| Project Title: | Great Oaks South Backup Generating Facility Small Power Plant Exemption |
| Document Title: | SV1 Responses to CEC Data Request Set 3 - GOSBGF |

RESPONSE TO CEC STAFF DATA REQUEST SET 3 (65-75)

Great Oaks South Backup Generating Facility (20-SPPE-01)

Revised Figure 2.3-1

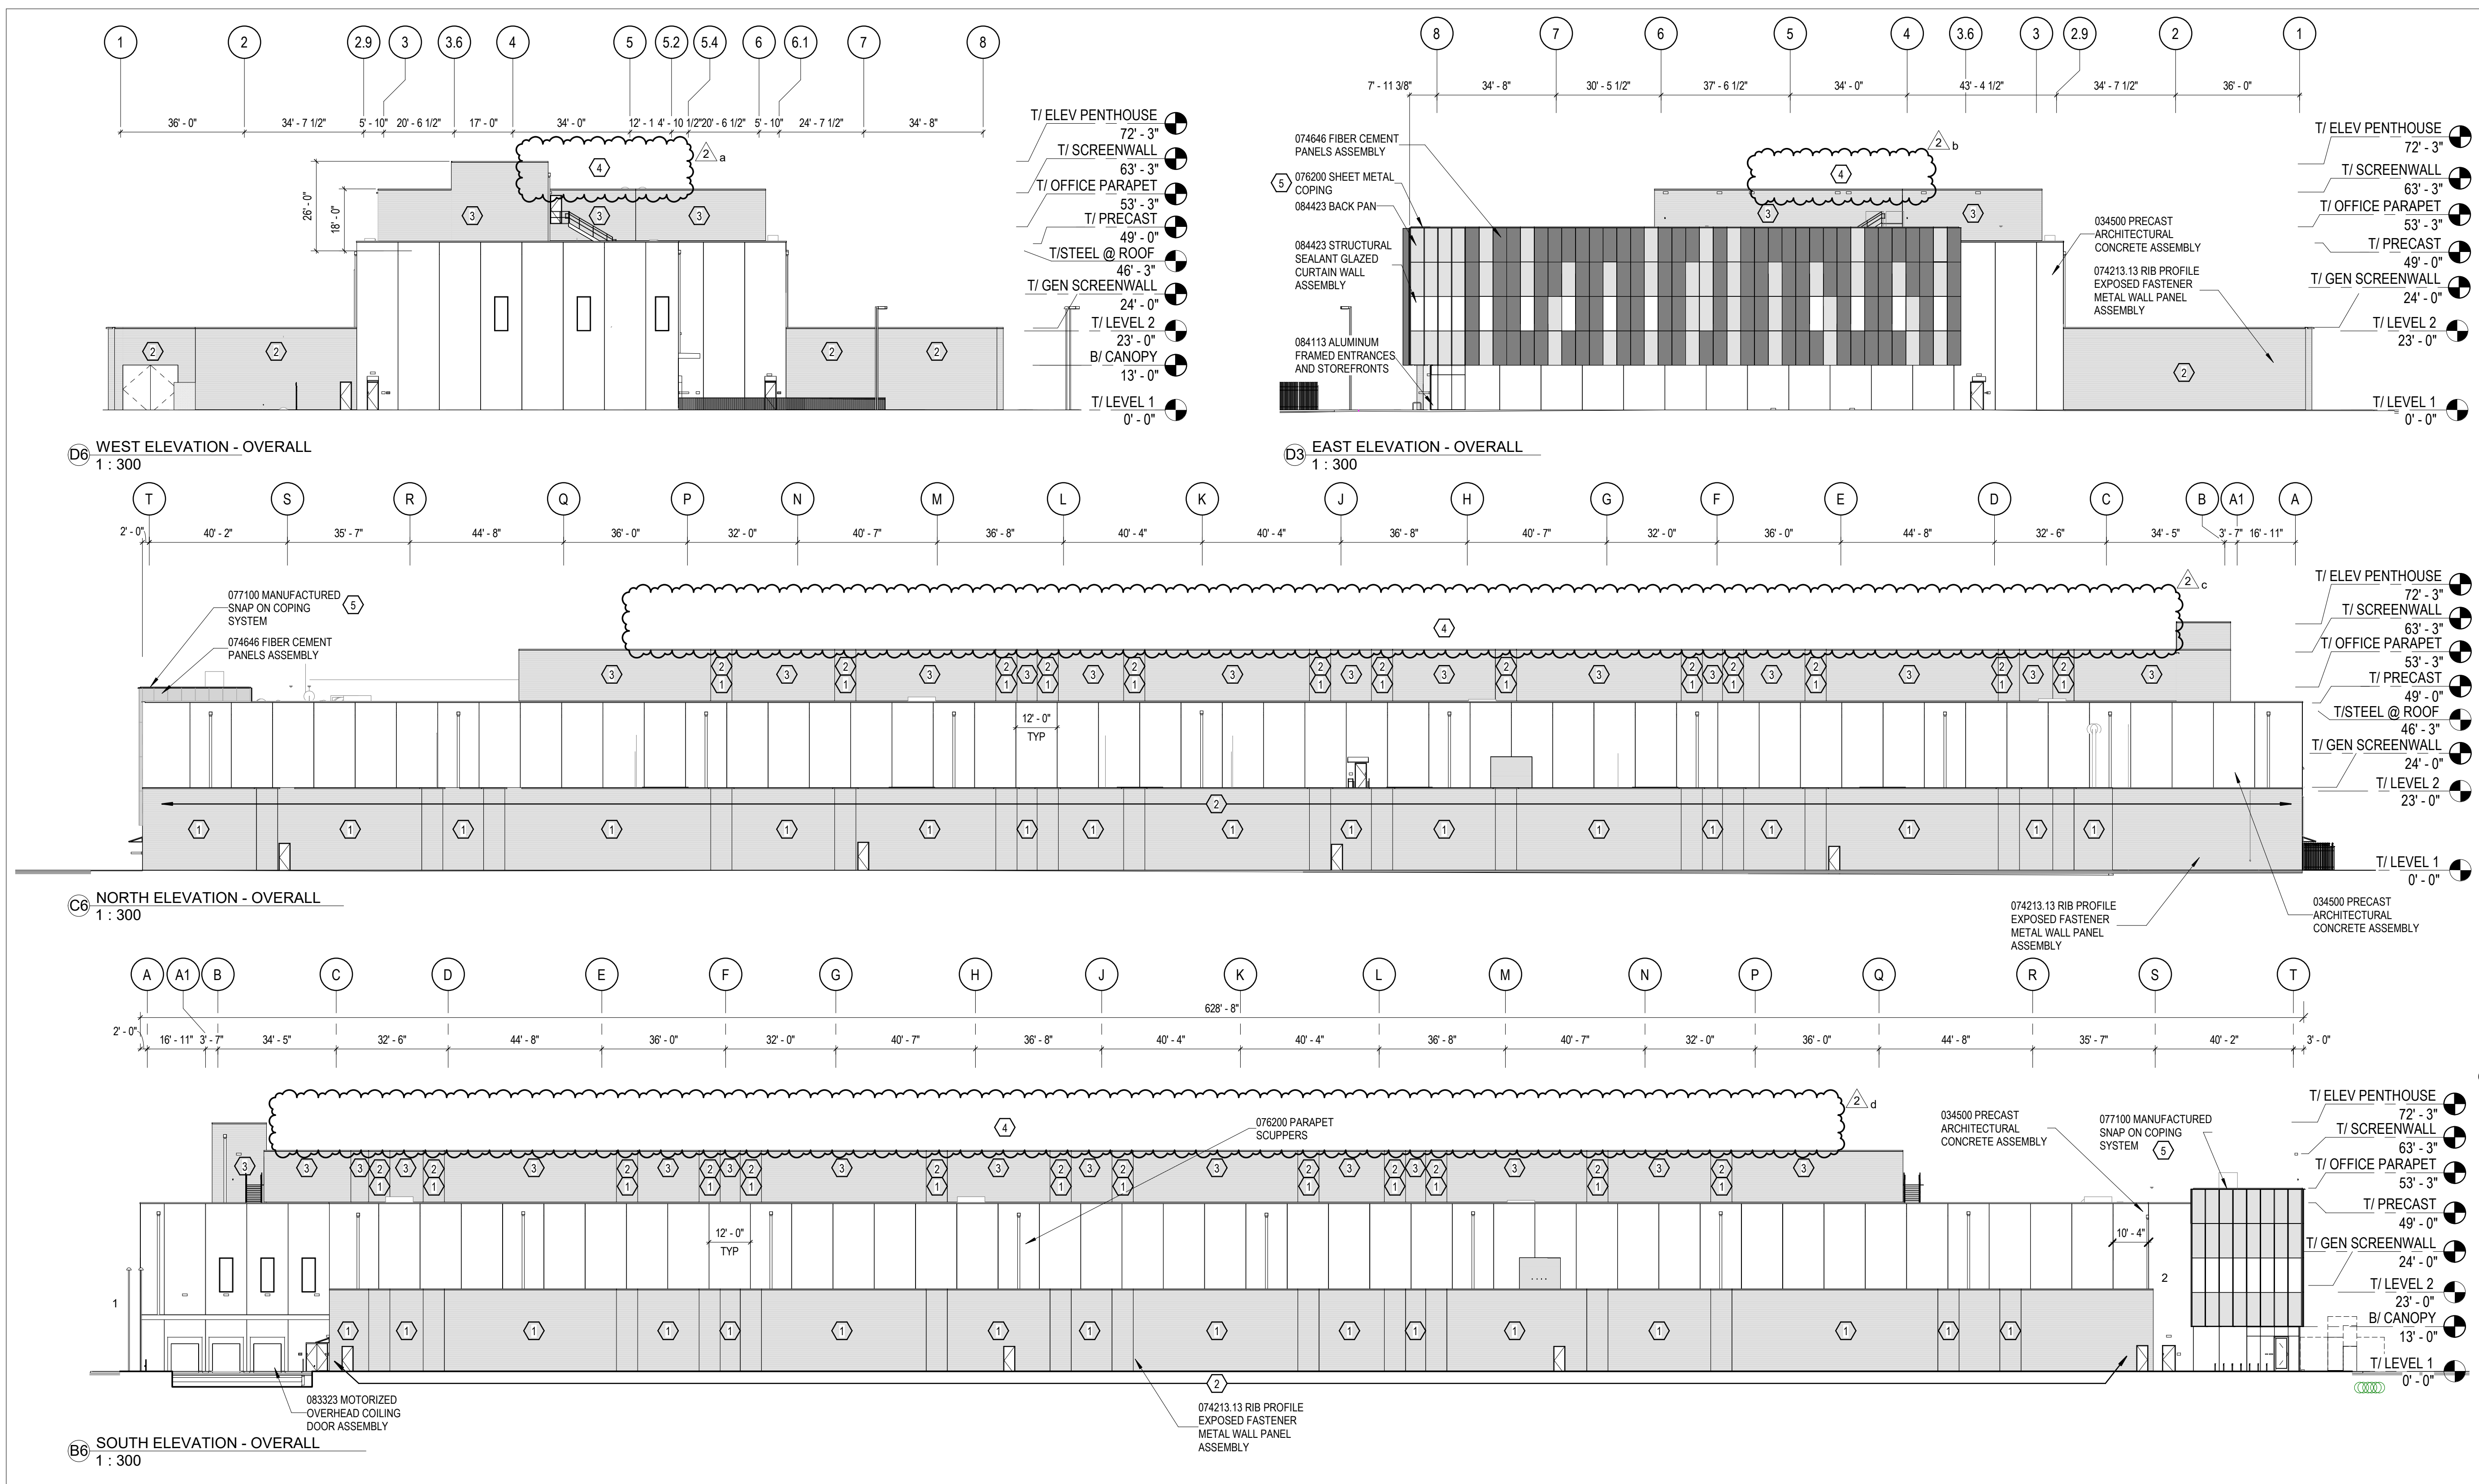
Section 2.3.2.1 of the SPPE application describes the data center buildings, stating that the two-story office component would be approximately 49 feet high (53 feet to the top of the parapet). Figure 2.3-1 shows the building elevations. In the figure, there are hexagon icons with numbers from 1–4, which suggests that there is a key missing from the figure. Also, the structures labeled “4” do not appear to correspond to the elevation marking for the penthouse, which is at 72 feet 3 inches.

73. Please provide a key for the numbers in the hexagon icons in Figure 2.3-1.

74. Please show what structures correspond to the elevation marking for the penthouse.

75. The top of the coping in Figure 2.3-1 appears to be some number of feet taller than the 49-foot-tall “precast.” Please explain if the top of the parapet (stated to be 53 feet in height) is the same thing as the “sheet metal coping” shown in Figure 2.3-1.

Figure 2.3-1 has been revised and is included in Attachment LU DR-73. The figure has been revised to address the Commission’s questions about heights in these data requests and to remove reference to cooling towers as they have been eliminated and replaced with air cooled chillers. The air cooled chillers will not be visible as they are behind and will be completely screened by the Screenwall.

The top of Screenwall for the penthouse (denoted T/Screenwall on Revised Figure 2.3-1) elevation is 63 feet 3 inches and the penthouse elevation will be 72 feet 3 inches.

Figure 2.3-1 has been revised to indicate that the top of sheet metal coping and top of parapet are the same elevation.
